Product Change Notice (PCN)

PCN Number: **PCN-0450656R-01**

Product(s) Affected: *PJ-018*

F-723-001

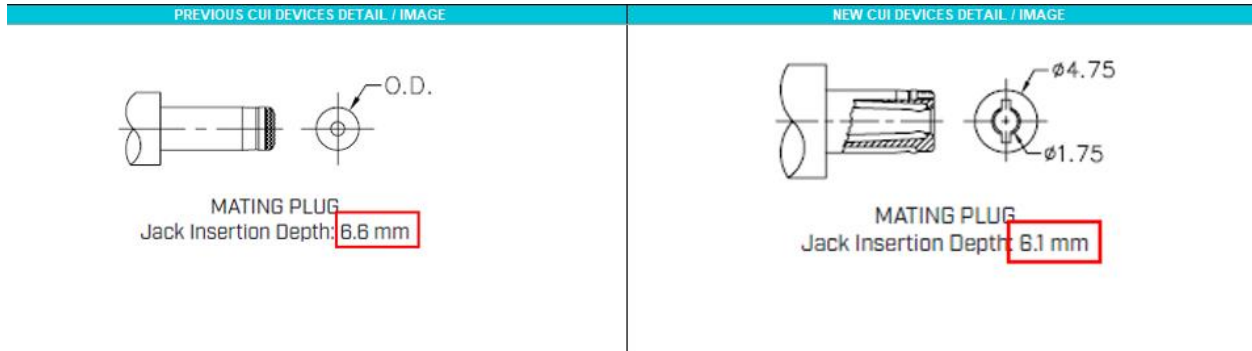
Description of Change: *Minor Housing and footprint differences. Material Change on the housing and terminals. See image Below*

MATERIAL	PLATING
center pin	copper	nickel
terminal 1	brass	tin
terminal 2	copper alloy	tin
terminal 3	brass	tin
plastic	PBT

SOLDERABILITY

parameter	conditions/description	min	typ	max	units
wave soldering	dipped in solder pot for 5 +0.5 seconds	255	260	265	°C

DESCRIPTION	MATERIAL	PLATING/COLOR
center pin	brass	CuSnNi
terminal 1	brass t=0.4	silver
terminal 2	phosphor bronze t=0.25	silver
terminal 3	brass t=0.4	silver
housing	PA10T (UL94V-0)	black

SOLDERABILITY

parameter	conditions/description	min	typ	max	units
wave soldering	dipped in solder pot for 4-8 seconds		250		°C
